LIMITING CONDITIONS
FOR OPERATION

3.5.A Core Spray &
LPCI Subsystem

4.5.A Core Spray &
LPCI Subsystem (cont'd)

CORE SPRAY SYSTEM
SINGLE LOOP PIPING
EXISTING ARRANGEMENT
DWG. 1

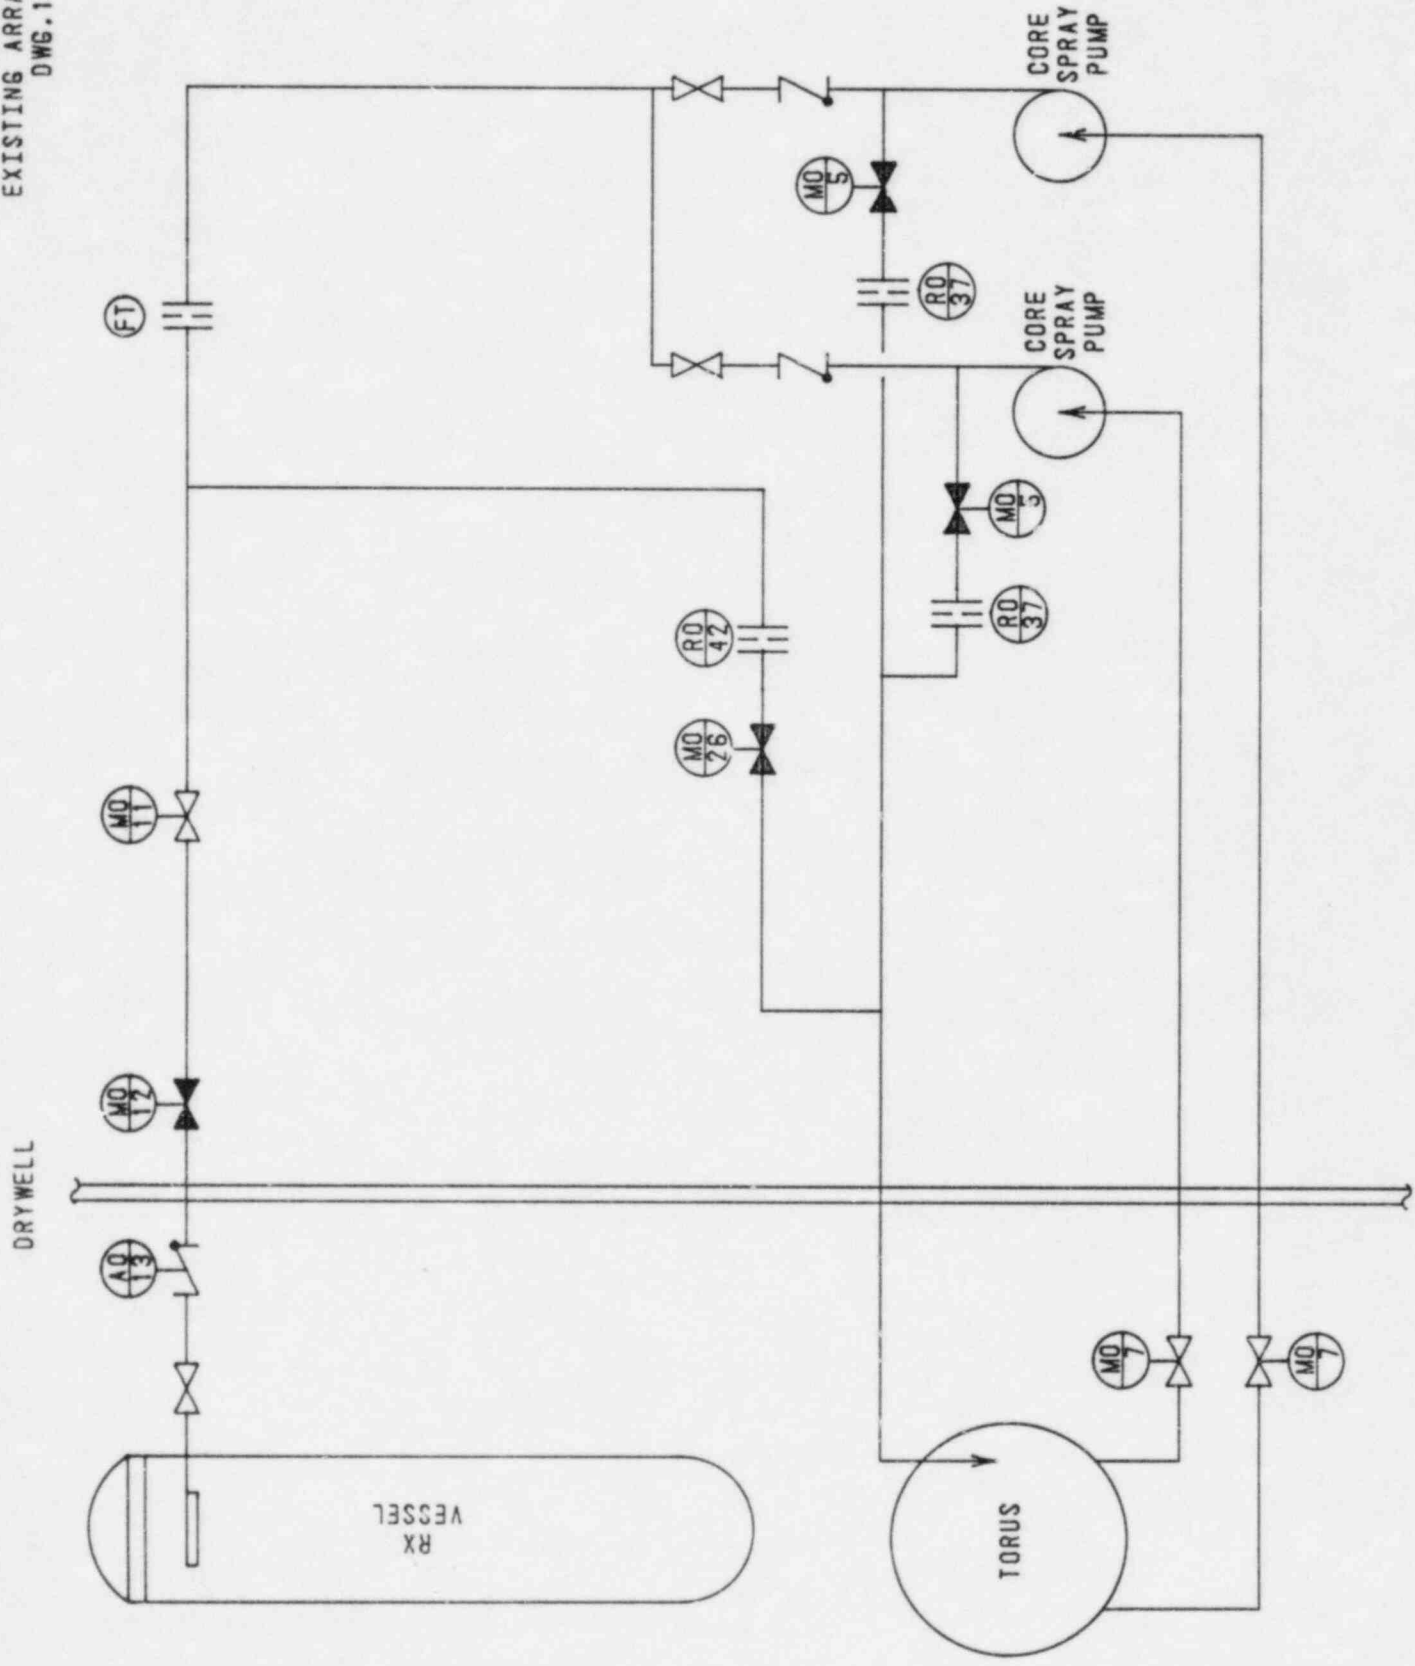
<u>Item</u>	<u>Frequency</u>
(d) Pump Flow Rate	Once/3 months
*Each Pump in each loop shall deliver at least 3125 gpm against a system head corresponding to a reactor vessel pressure of 105 psig.	
(e) Core Spray Header P Instrumentation	
Check	Once/day
Calibrate	Once/3 months
(f) Operability	In accordance
check to ensure that pumps will start and motor operated injection valves will open.	with 4.5.A.2, 4.5.A.4 and 4.5.A.5.
2. When it is determined that core spray subsystem is inoperable, the operable core spray subsystem and the LPCI subsystems shall be demonstrated to be operable in accordance with 4.5.A.1(f) and 4.5.A.3(e) within 24 hours and at least once per 72 hours thereafter until the inoperable core spray subsystem is restored to operable status.	
3. LPCI Subsystem Testing shall be as follows:

*Until the required modification is completed, the loop flow rate test at 6250 gpm against a system head corresponding to a reactor vessel pressure of 105 psig will be performed to satisfy surveillance requirements.

CORE SPRAY SYSTEM
 SINGLE LOOP PIPING
 PROPOSED ARRANGEMENT
 DWG.2
